Project:
**Land off Basingstoke Road
Spencers Wood**

Project No:
T23591
Report Title:
Transport Assessment Addendum

Prepared by:	MF
Authorised by:	JP
Rev:	A
Date:	10/02/2026

TITLE
PROPOSED SITE ACCESS
ROUNDABOUT JUNCTION

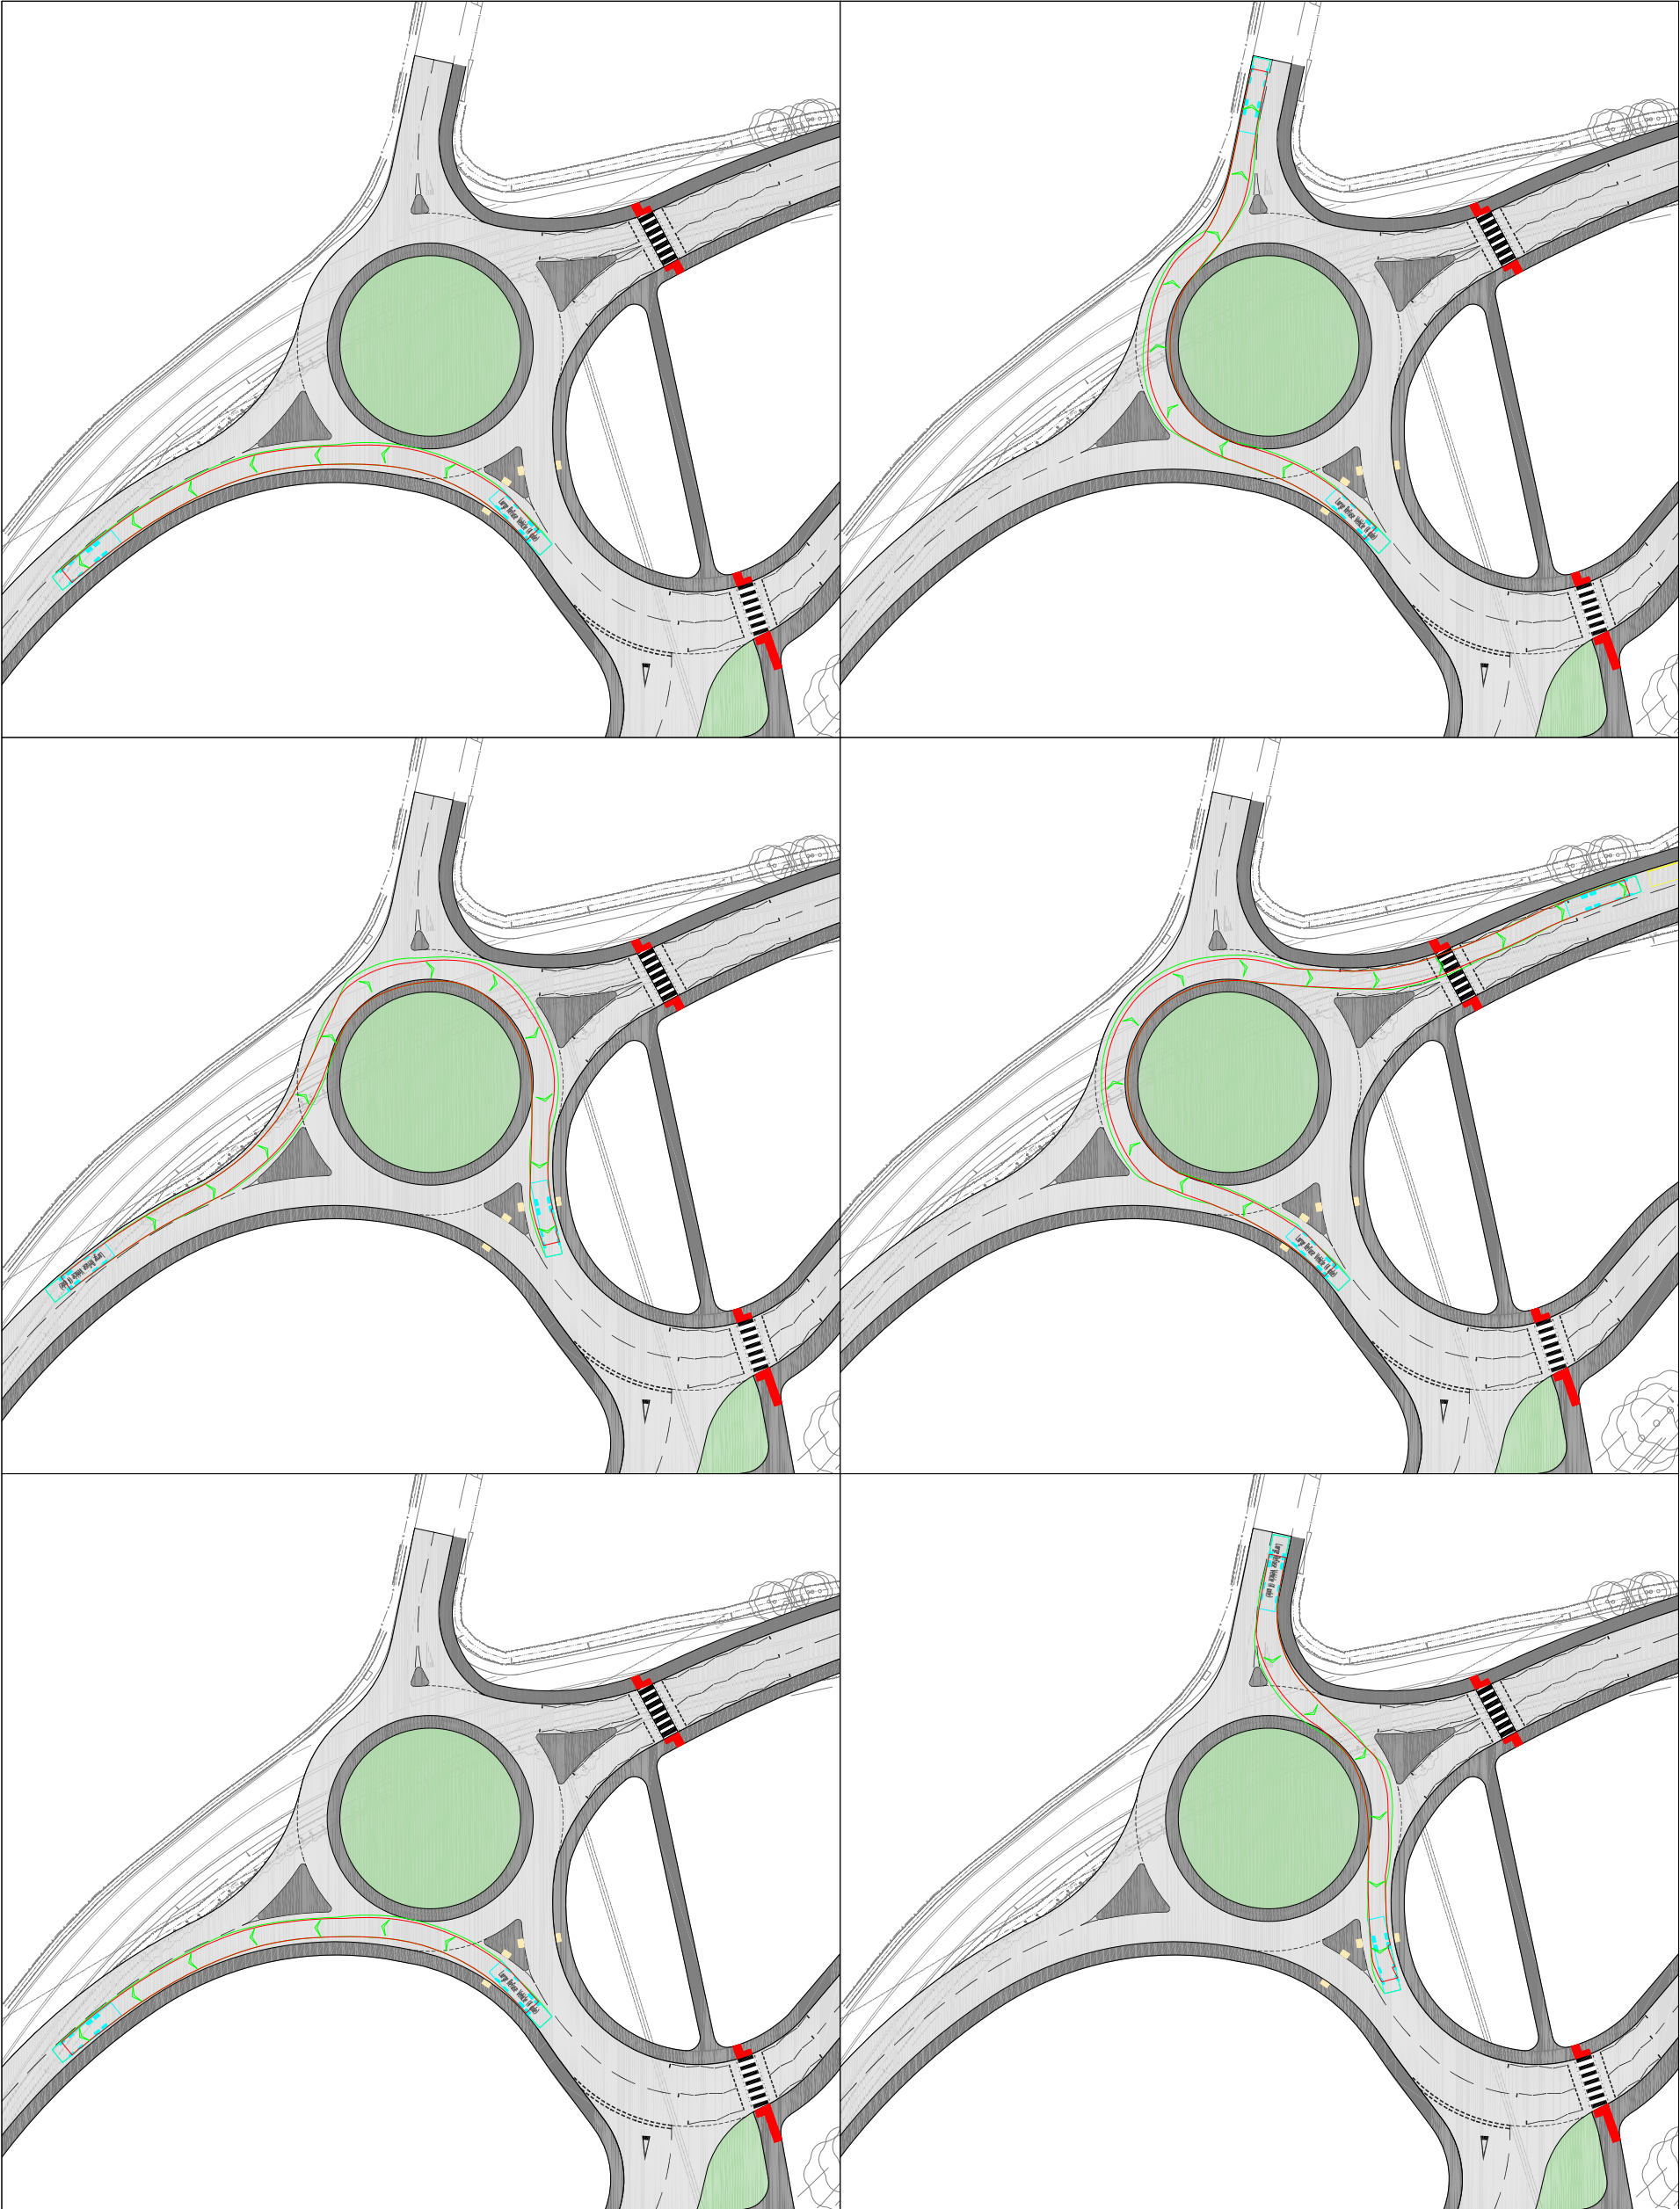
Vehicle Accesses	
The LHA require the following additional amendments relating to access: - A Stage 1 Road Safety Audit of the submitted access junctions. - Confirmation that forward visibility does not cross third party land. The forward visibility crosses an adjacent land parcel, and it is not clear if this land falls within control of the applicant. - Relocation of the zebra crossings to provide greater separation between the zebra crossing and the circulatory carriageway. There is c.6.4m between the zebra crossing and the circulatory carriageway. A 16.5m articulated lorry or 10m rigid lorry would overhang into the carriageway creating the possibility of rear end shunts whilst giving way to pedestrians. - Demonstrate 2.4m x 43m visibility from the internal T-junction in accordance with the Manual for Streets requirements for a 30mph speed limit.	In response to each point raised by WBC: - A Stage 1 Road Safety Audit (RSA) and designers response for the site accesses are provided in Appendix C; - We can confirm that forward visibility on both B3349 Basingstoke Road approaches to the proposed roundabout are within land controlled by the applicant as shown by the Application Boundary Plan dated 13th February 2025 (ref: R-SPWD-ABP-01 rev D) that is on the planning portal. - The zebra crossing has been moved 18m north of the roundabout and is shown in Drawing T23591.001 rev C; and - The visibility splays for the internal access junction have been added and are shown in Drawing T23591.001 rev C. While this has been shown for 2.4m x 43m, it is likely that vehicles exiting the roundabout will be travelling slower than 30mph.

- c. Relocation of the zebra crossings to provide greater separation between the zebra crossing and the circulatory carriageway. There is c.6.4m between the zebra crossing and the circulatory carriageway. A 16.5m articulated lorry or 10m rigid lorry would overhang into the carriageway creating the possibility of rear end shunts whilst giving way to pedestrians.

C	DRAWING UPDATED IN LINE WITH LHA ATE AND STAGE 1 RSA FEEDBACK	26.01.26	MF	JP
B	DRAWING UPDATED IN LINE WITH LHA AND ATE FEEDBACK	05.08.25	MF	JP
A	DRAWING UPDATED IN LINE WITH CLIENT REQUIREMENTS	19.03.24	JP	GM

CLIENT				
RICHBOROUGH				
PROJECT				
SPENCERS WOOD				
TITLE				
PROPOSED SITE ACCESS PRIORITY JUNCTION & PED/CYCLE ACCESS				
DRAWN	AUTHORISED	SCALE	SHEET SIZE	DATE
CR	JP	1:1250	A3	06.02.24
PROJECT NO.		DRAWING NO.		REV/
T23591		004		C

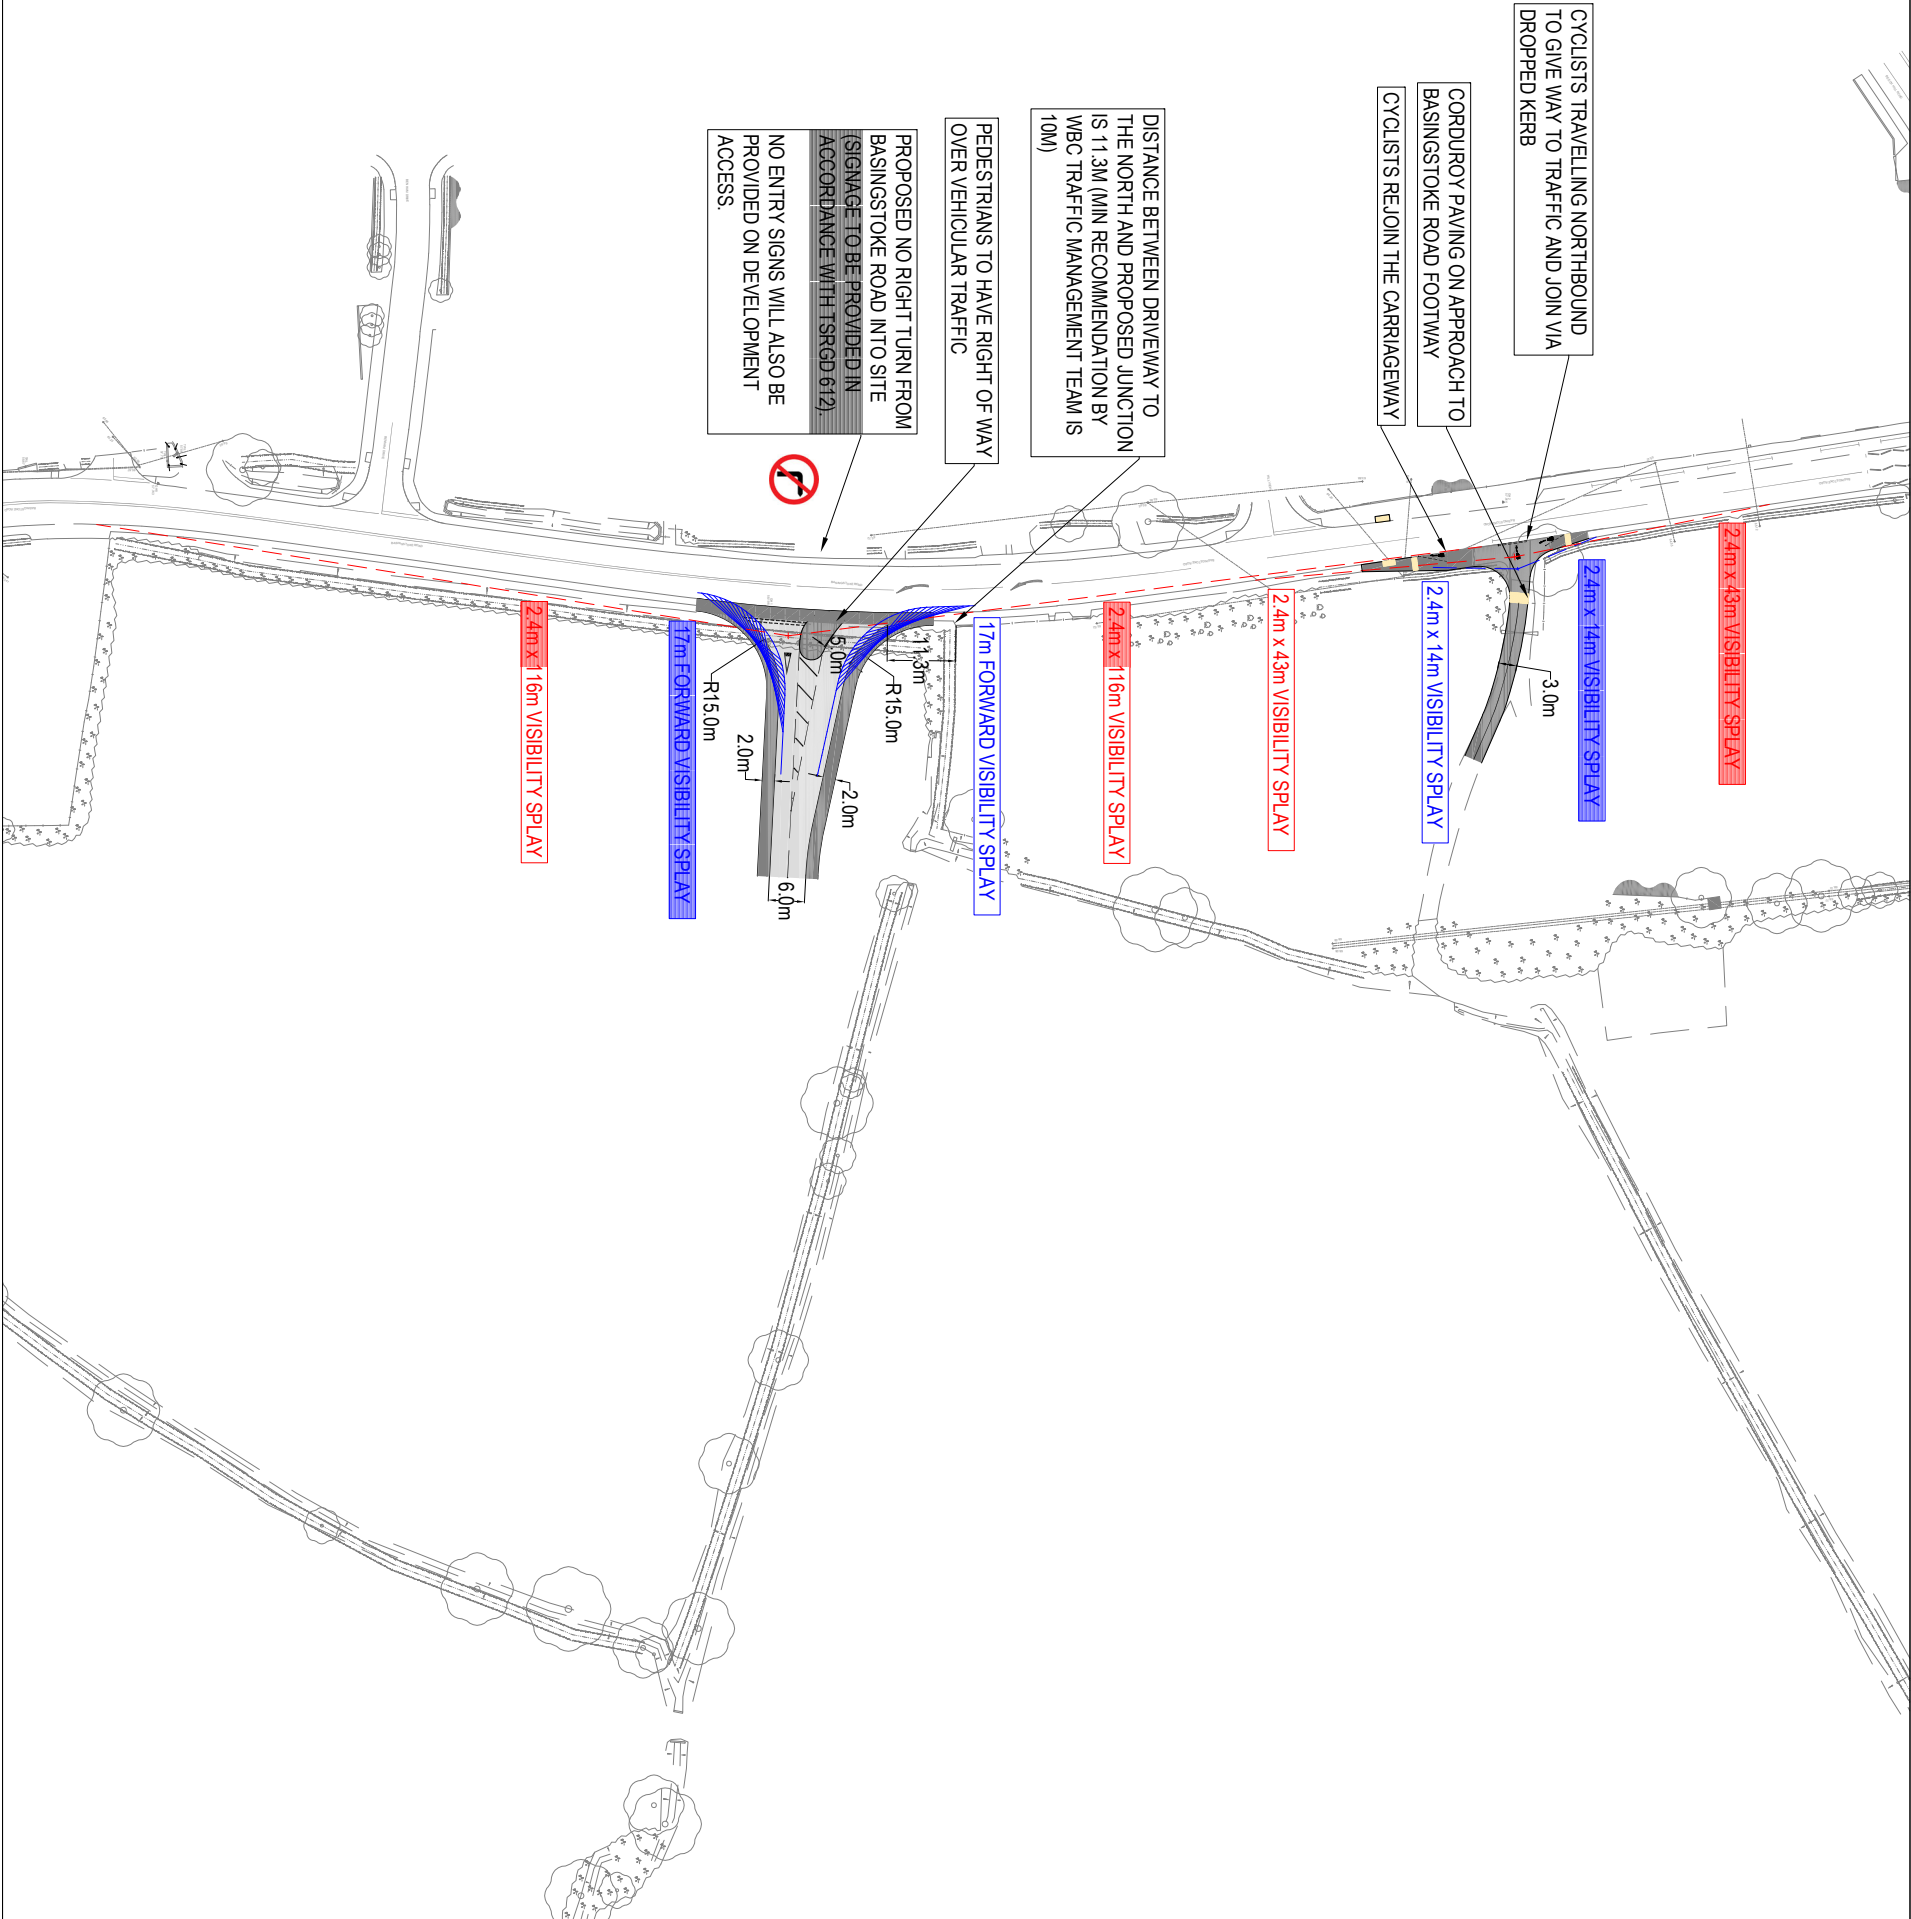
The LHA also require suitable visibility in accordance with the Manual for Streets to be demonstrated from the point cyclists give way to vehicles. The TA shows visibility of other cyclists; but not of vehicles travelling along the B3349.	Agree, a 2.4m x 43m visibility splay has been shown on Drawing T23591.001 rev C .
The TA also outlines that: 'Additional, there would be segregated pedestrian/cycle accesses connecting to the existing PROW off Hyde End Road and the park via Century Drive, to make the site as permeable as possible for pedestrians and cyclists. These accesses would connect with land that has been adopted by WBC (either as public open space or adopted highway) and are therefore deliverable'	Linked to the points above, these access points would provide greater permeability to the existing network and subsequently more direct routes.
The TA states that: 'The PROW to the north of the site that connects with Hyde End Road will be improved to provide all-weather surfacing and lighting'.

2.5	No details have been provided to confirm that there is sufficient visibility between pedestrians/cyclists exiting the proposed development shared pedestrian/cycle access and users of the footway along the eastern side of Basingstoke Road. Poor visibility may lead to potential collisions between non-motorised road users	Ensure that visibility splays to and from the proposed development shared pedestrian/cycle access and the footway along the eastern side of Basingstoke Road is provided.	Accepted. Visibility splays for the proposed pedestrian/cycle access are provided in Drawing T23591.004 rev C.
